PLANNING CLEARANCE

Building Address 2078 Raindance Ct No. of Existing Bldgs 1 No. of Proposed 1

Other (please specify): POOL

Subject: Proposed Pool
2078 Raindance Court
Grand Junction, Colorado

Plot for 2078 RAINING OF

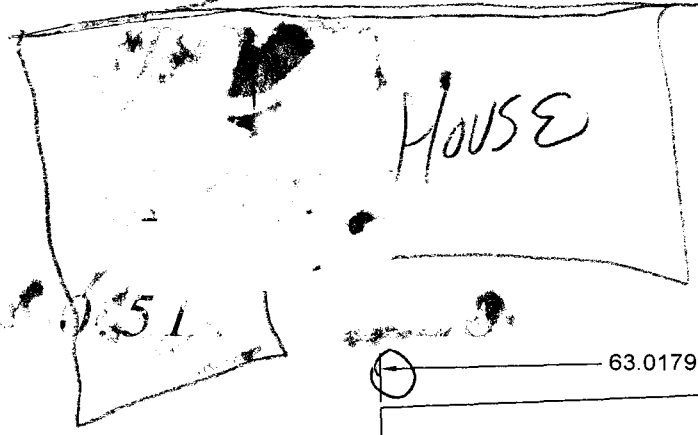
NOTES: Swimming Pool - needs
Engineer Soils Report

Root System Disturb^d/Removal

Set Backs

Layout?

Maximum Height of Structure(s) _____ Special Conditions Per PD & required
engineers Soils Report
